March 9, 1984
LIC-84-066

Masonry Wall Design
IE Bulletin 80-11

RESPONSE TO
REQUEST FOR ADDITIONAL INFORMATION
MASONRY WALL DESIGN, IE BULLETIN 80-11
FORT CALHOUN STATION

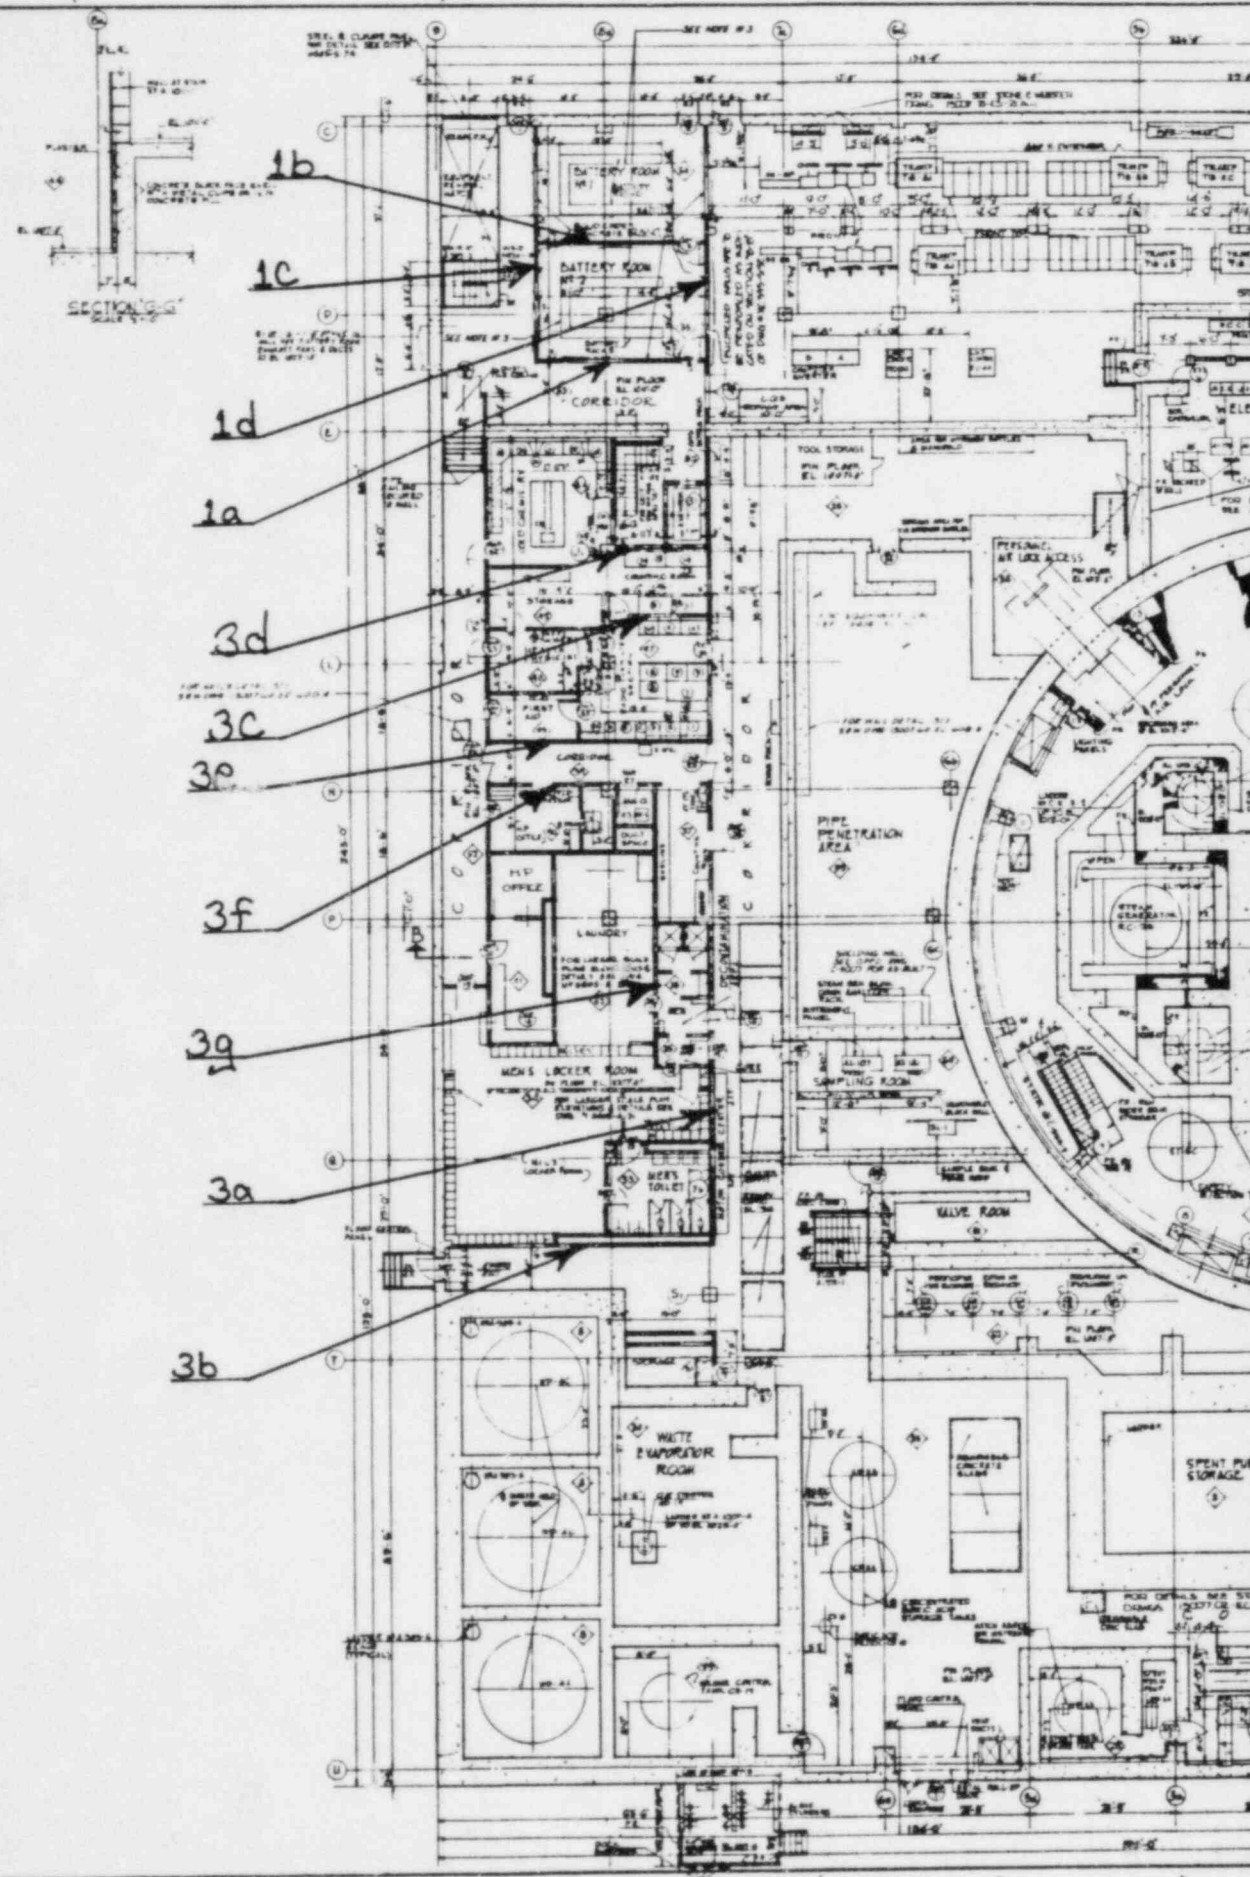
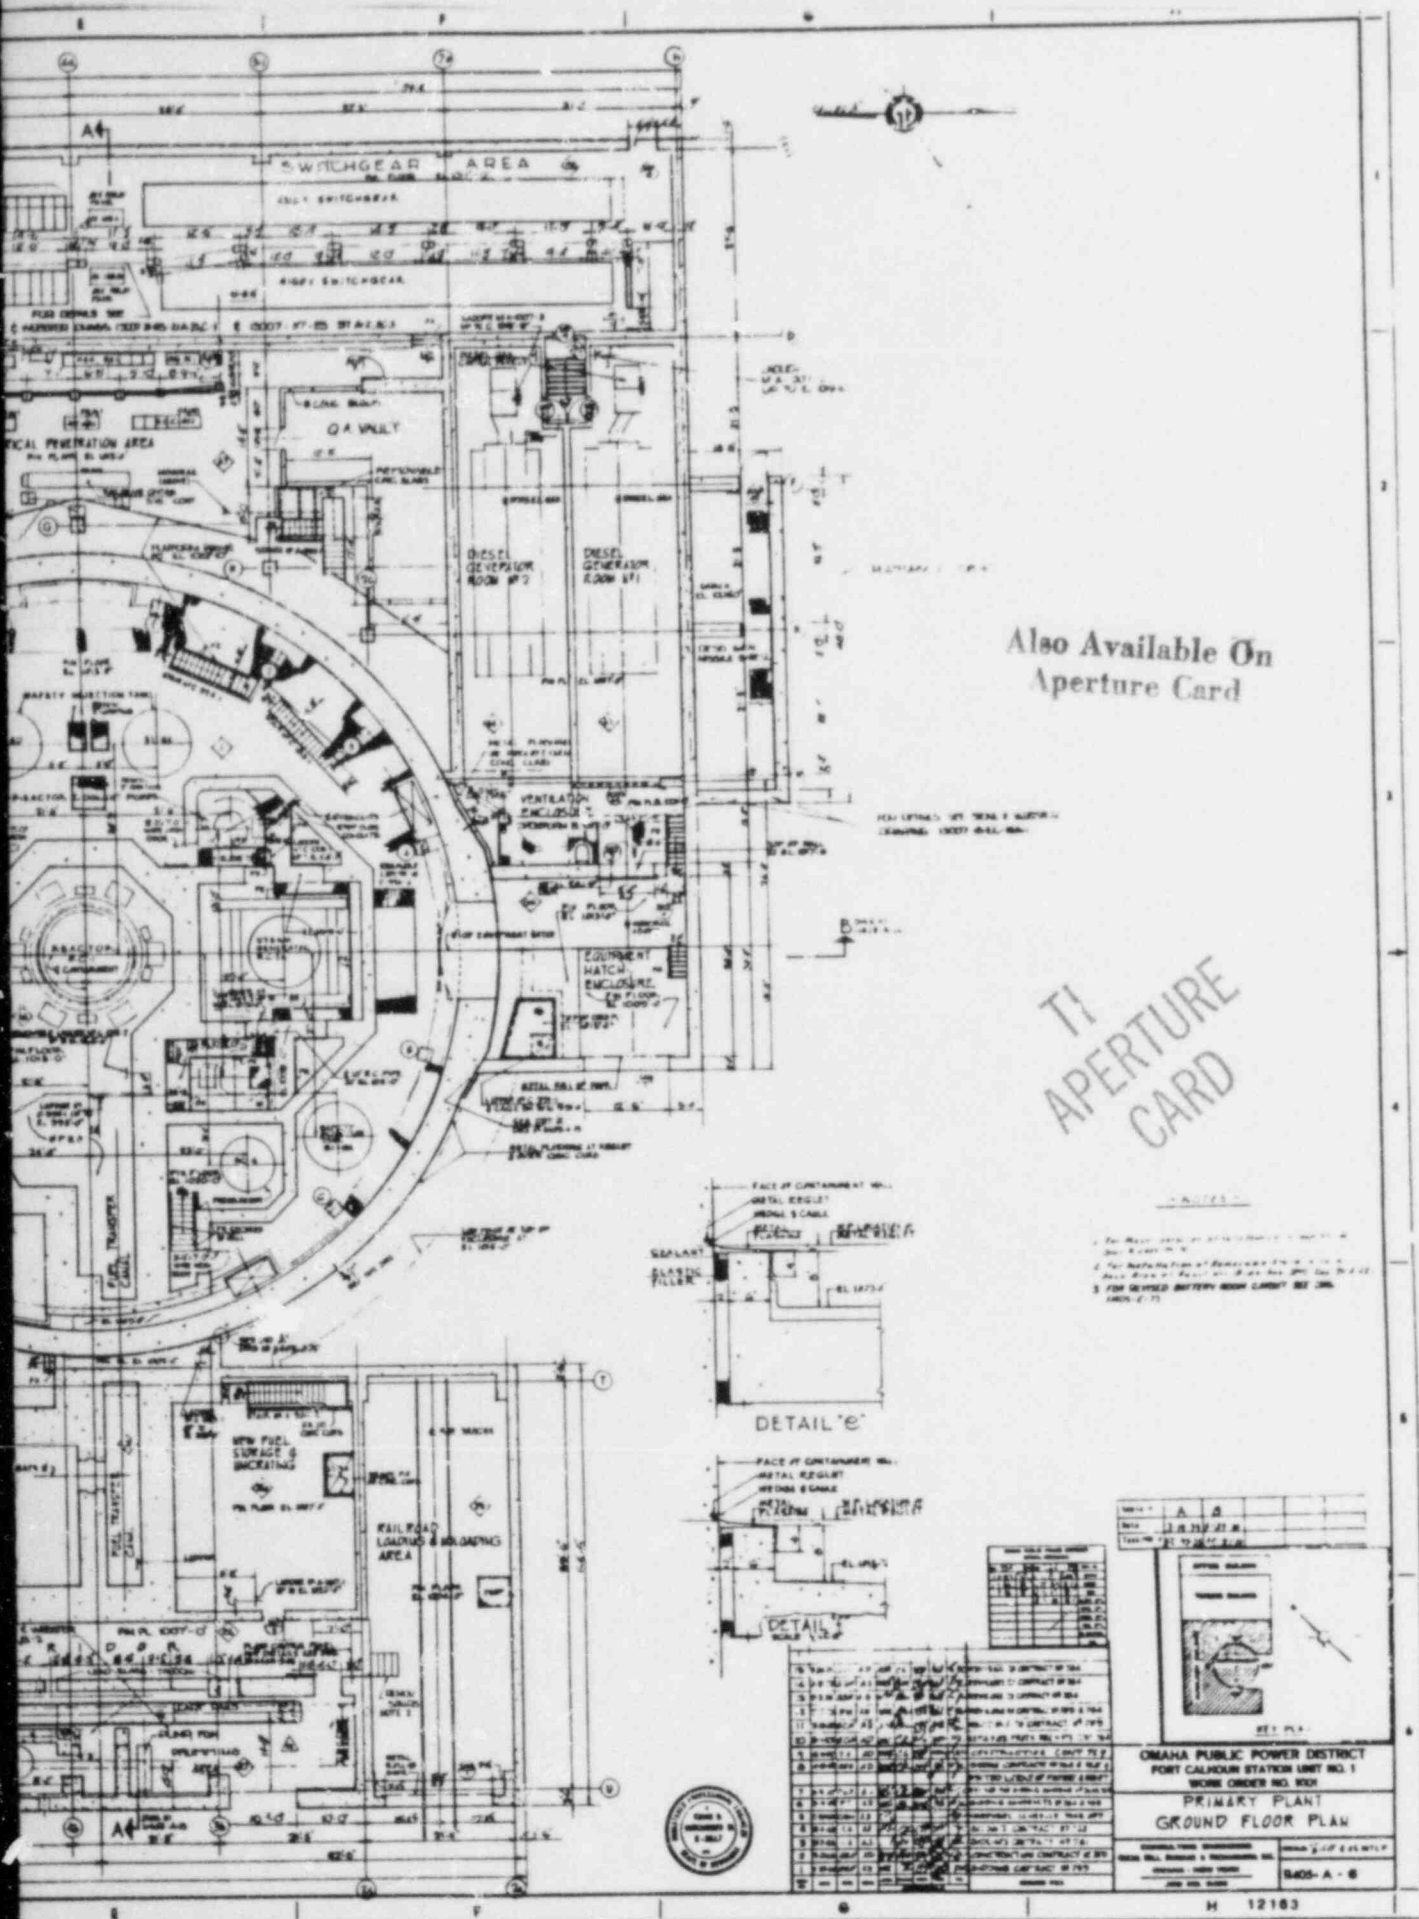
ANSWER: The masonry walls were originally qualified based on the arching action theory. In response to the Request for Additional Information by NRC dated February 6, 1984, the walls were re-evaluated based on the working stress approach. All walls were treated as unreinforced concrete masonry walls. It is found that 13 walls out of 22 walls do not qualify for the seismic loading calculated with the dynamic analysis approach, if wall capacity is established based on working stress theory. The following walls will require modifications: (See the attached drawings)

1) Battery Room:

- a) West Wall Room #2
- b) East Wall Room #2
- c) North Wall
- d) South Wall

2) Control Room:

- a) West wall between Control Room & Computer Room
- b) South wall of Computer Room

3) Auxiliary Building

- a) North Wall of Corridor between Column Line 7a and 7b
- b) East Wall of Corridor between Column Line Q and T
- c) West Wall of Counting Room between Counting Room and Chemistry Room
- d) East Wall of Counting Room
- e) East Wall of Corridor between Column Line L and N
- f) West Wall of Corridor between Column Line L and N
- g) North Wall of Decontamination Room

The District will repair or modify these walls as necessary so that they will comply with the design criteria in accordance with the working stress theory and qualify them for seismic loading.
